# Puri Zila School Puri

## 1. About the Building

## Audit Report

## 2. Alighting

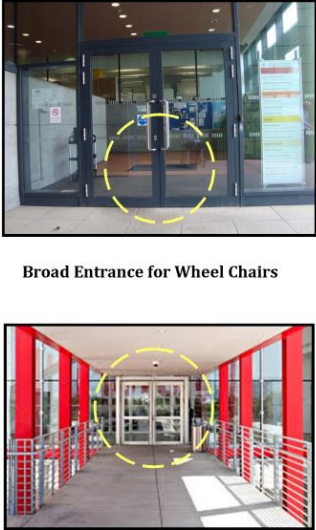
Issues Observed	Recommendation
Not Applicable	Traffic police to be requested to allow extra parking time for entry and exit from vehicles.

### 4. Entrance

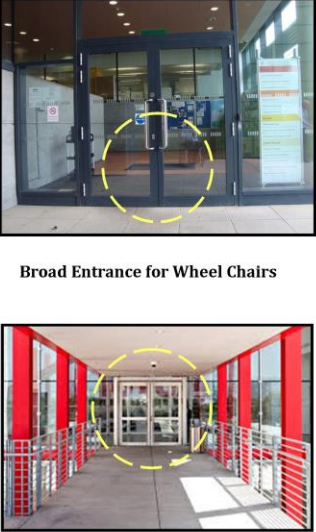
Issues Observed	Photograph	Recommendation	Technical Recommendation
<ol style="list-style-type: none"> <li>1. Two Inaccessible Ramp available. One is third entrance of school and another is Infront of conference hall building.</li> <li>2. Inaccessible iron handrail in ramp</li> <li>3. No Signage near entrance</li> <li>4. No difference in floor finish.</li> <li>5. Main building entrance height 518mm and conference hall entrance height 300mm</li> </ol>		<ol style="list-style-type: none"> <li>1. Accessible ramp to be reconstruct at the entrance left of faculty block with 1:12 gradient, accessible handrail and tactile tiles.</li> <li>2. Accessible ramp to be construct in all building entrance</li> <li>3. Floor finish to be distinguished (suggestion – thin rubber mat).</li> <li>4. Door mat should avoid.</li> <li>5. Illumination of 150 lux</li> </ol>	<p><b>SI# 4</b> <b>Accessible Entrance</b> <b>Examples of Best Practises</b></p>  <p><b>Broad Entrance for Wheel Chairs</b></p>

## 5. Reception and lobby

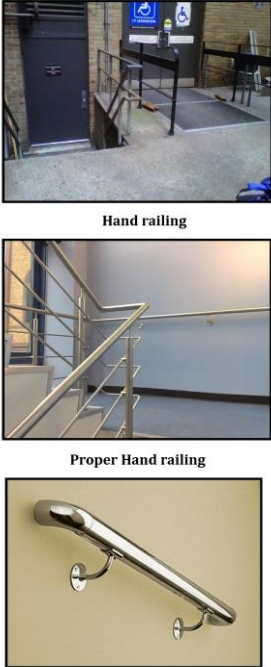
Issues Observed	Photograph	Recommendation	Technical Recommendation
<p>1. No reception and lobby.</p>		<ol style="list-style-type: none"> <li>1. Receptions counter to be establish near entrance.</li> <li>2. 900mm wide and 1200mm deep clear space in front of the reception counter.</li> <li>3. Non-reflective counter surface</li> <li>4. Counter height between 760 mm to</li> <li>5. 800mm from the floor with a 400mm to 600mm clear recess under the counter.</li> <li>6. Accessible identification signage near reception counter with odiya , English Language.</li> <li>7. Guide map of building adjacent to reception.</li> <li>8. Accessible directional signage directing to various building facilities at the reception</li> </ol>	<p><b>SI# 5</b> <b>Reception and Lobby</b> <b>Examples of Best Practises</b></p>  <p>Wheel Chair Accessible Reception</p>

## 8. Corridor

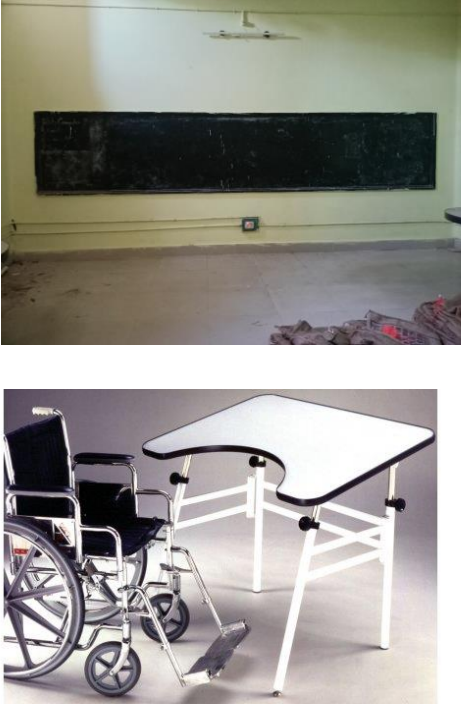
Issues Observed	Photograph	Recommendation	Technical Recommendation
<ol style="list-style-type: none"> <li>1. Building corridor width is more than 3048 mm.</li> <li>2. 1500 mm x1500mm space for wheelchair 360° turn.</li> <li>3. No grip bar on wall. No guiding tiles.</li> <li>4. Floor finish Non slippery</li> <li>5. Good Colour Contrast.</li> <li>6. Corridor obstructed by chairs.</li> <li>7. Notice board height is 1600 mm.</li> <li>8. Good illumination</li> </ol>		<ol style="list-style-type: none"> <li>1. Grab bars on both sides of the corridor.</li> <li>2. Protruding objects to be removed or re-arranged.</li> <li>3. Notice board should establish in the height of 900mm.</li> <li>4. Obstacles to be removed.</li> </ol>	<p><b>SI# 12</b> <b>Door and Doorways</b> <b>Examples of Best Practises</b></p>  <p style="text-align: center;"><b>Accessible Doors and Doorways</b></p>

## 10. Classrooms

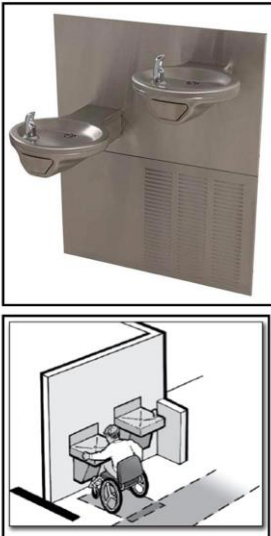
Issues Observed	Photograph	Recommendation	Technical Recommendation
<ol style="list-style-type: none"> <li>1. Inaccessible furniture.</li> <li>2. Accessible blackboard in classrooms.</li> <li>3. Blackboard height 640 mm</li> </ol>		<ol style="list-style-type: none"> <li>1. 900 mm height, 900mm wide and 1200mm deep clear space in front of the book issue counter</li> <li>2. should have adequate space for the wheelchair of 1500mm in the reading room.</li> <li>3. There should be a gap of 1200mm between bookshelves.</li> <li>4. Jaw's software to be install in at list 5 computers.</li> <li>5. There should be audio books and braille books.</li> <li>6. Black board height should be in 900 mm to 1200 mm.</li> <li>7. There should be proper illumination of 250 lux in classroom.</li> <li>8. There should be 1200 mm space to move the wheelchair in the classroom.</li> <li>9. Teacher should be trained to teach student with disability.</li> </ol>	<p data-bbox="1727 331 1995 411"><b>Sl# 14</b> <b>Cafeteria</b> <b>Examples of Best Practises</b></p>  <p data-bbox="1749 935 1984 986">Accessible Tables in the Cafeteria Highlighted circle shows knee space for wheel chair users</p>
